**RE: Johnstone Supply Warehouse
2624 Vassar Dr. NE
Grading & Drainage Plan
Engineer's Stamp Date: 07/11/23
Hydrology File: H16D155**

Based upon the information provided in your submittal received 08/07/2023, the Grading & Drainage Plan is approved for Building Permit, Grading Permit, and SO-19 Permit. Please attach a copy of this approved plan in the construction sets for Building Permit processing along with a copy of this letter.

SHEET TITLE:
**GRADING &
DRAINAGE PLAN**

C101

A2 GRADING & DRAINAGE PLAN
1"=20'

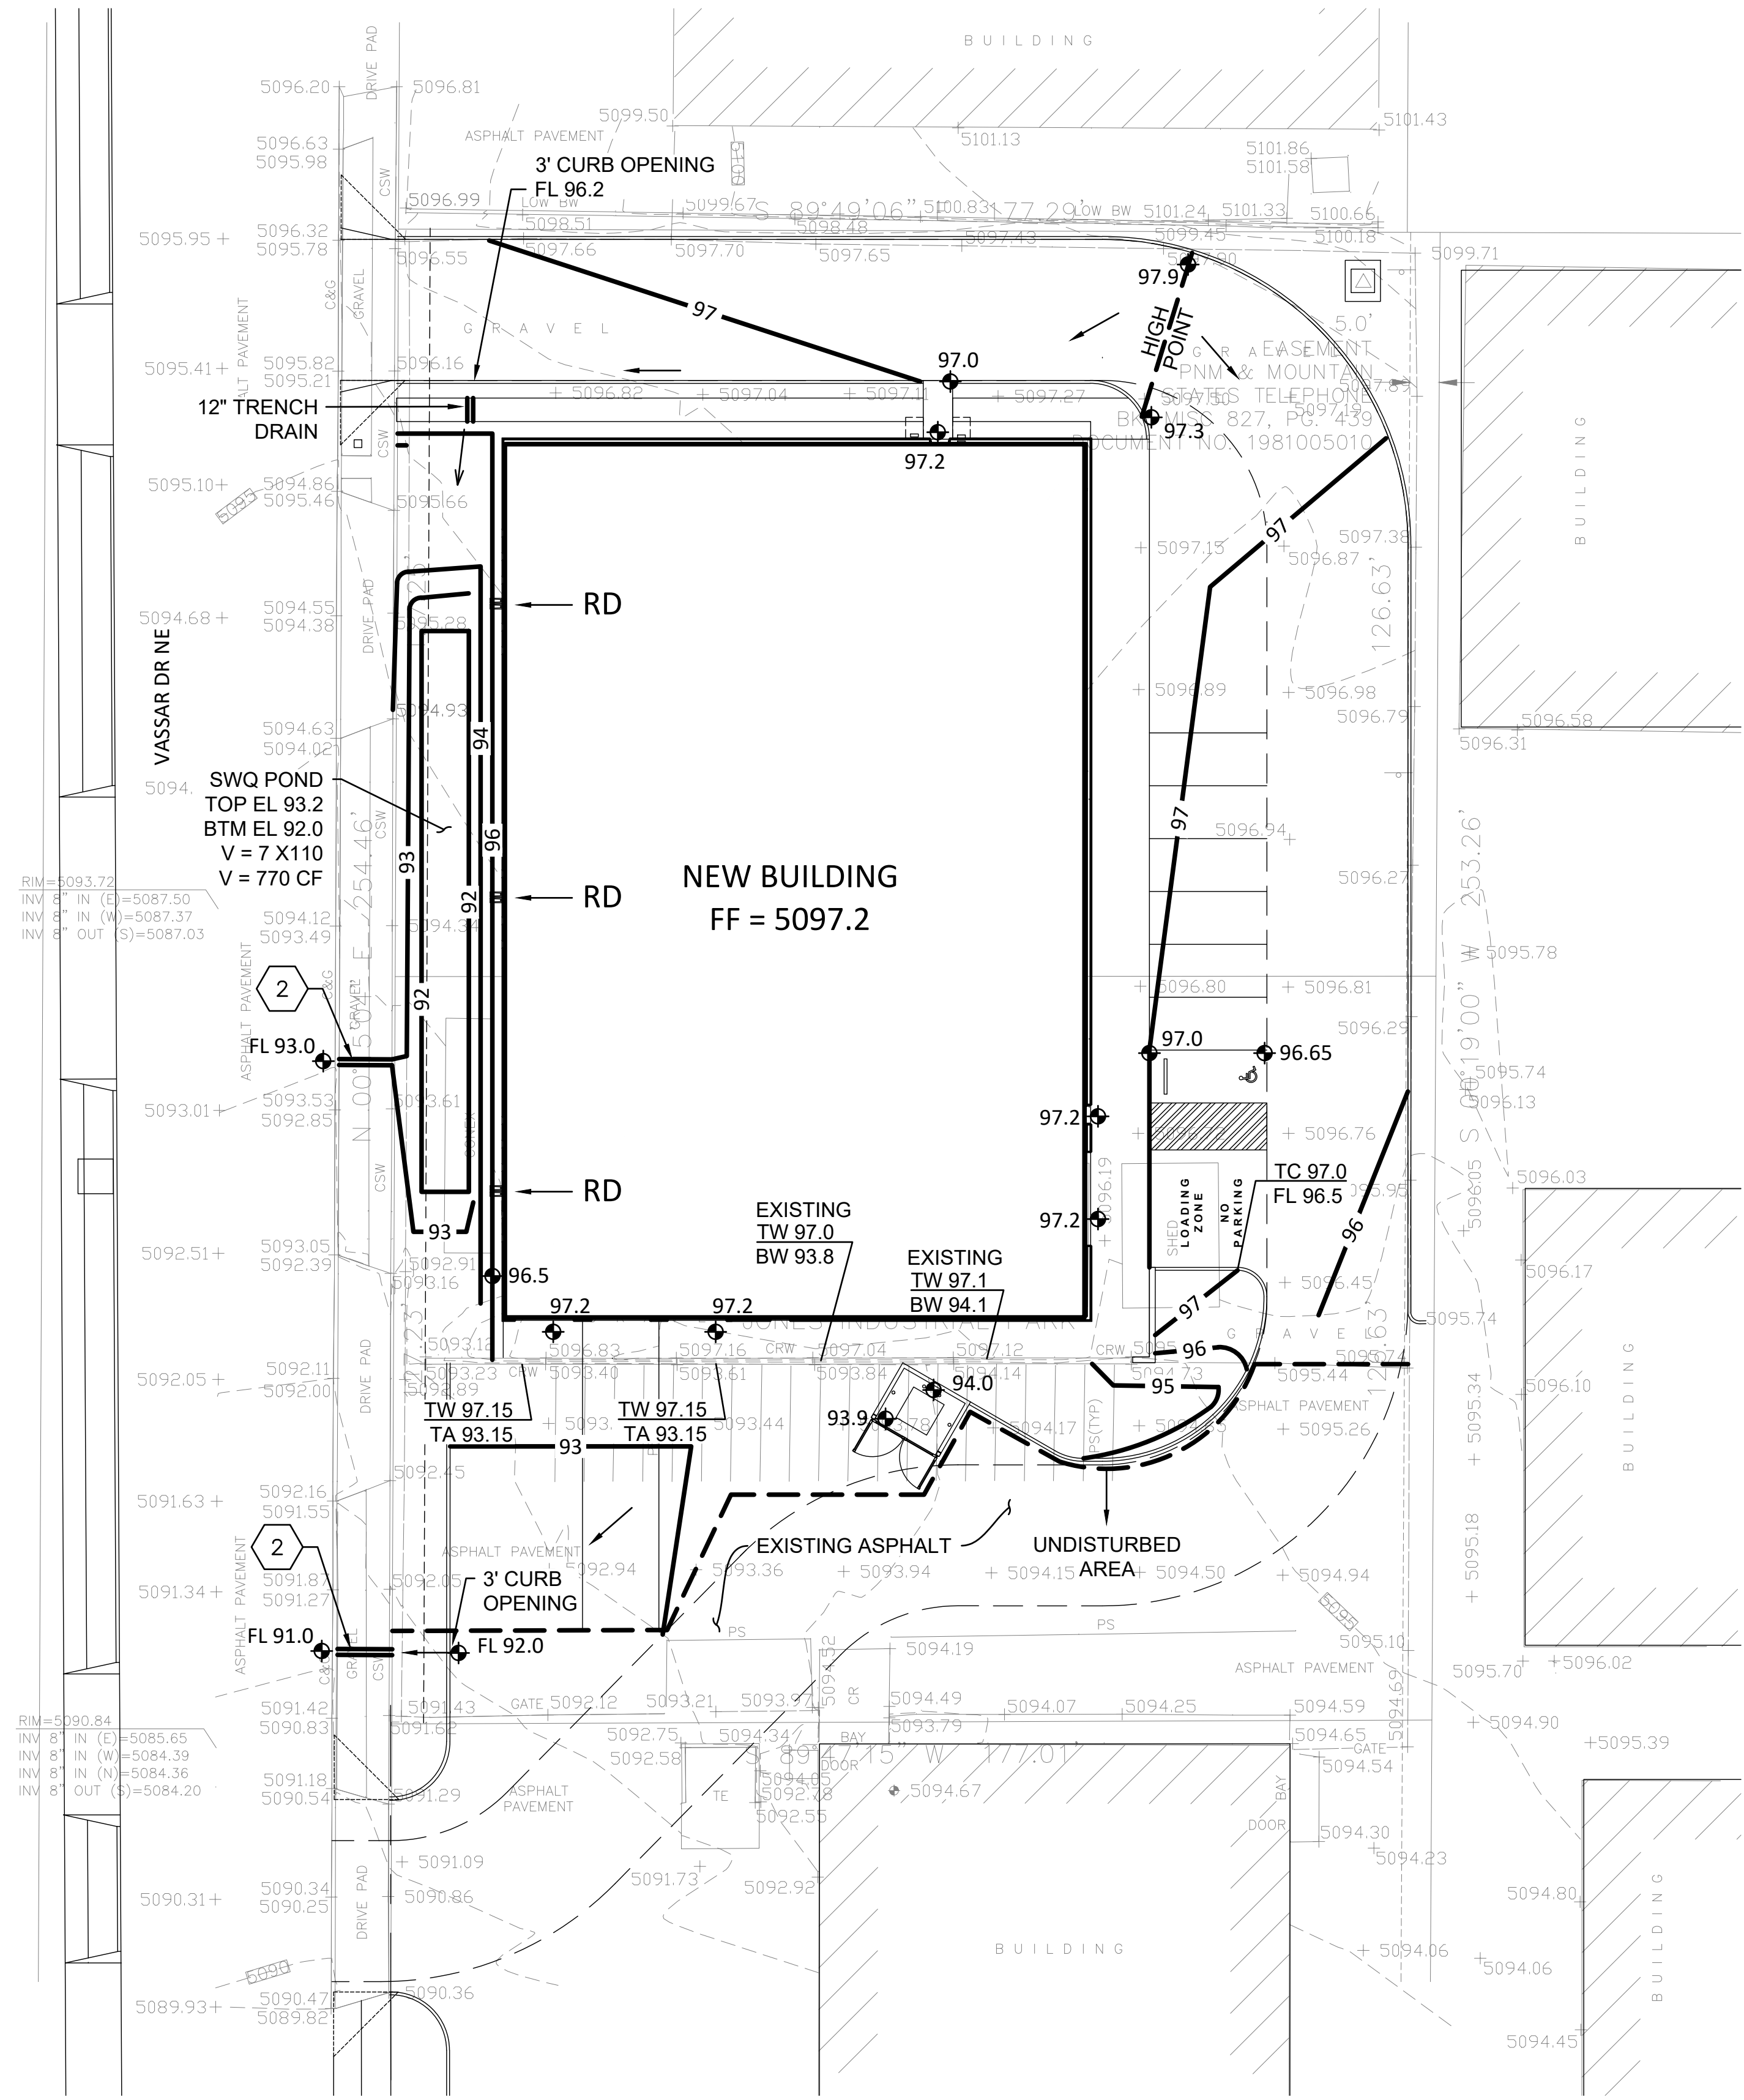
1. Engineer's Certification, per the DPM Part 6-14 (F): *Engineer's Certification Checklist For Non-Subdivision* is required.

2. Please provide the executed paper Drainage Covenant (latest revision) printed on one-side only with Exhibit A and a check for **\$25.00** made out to "**Bernalillo County**" for the stormwater quality pond per Article 6-15(C) of the DPM to Hydrology for review at Plaza de Sol.
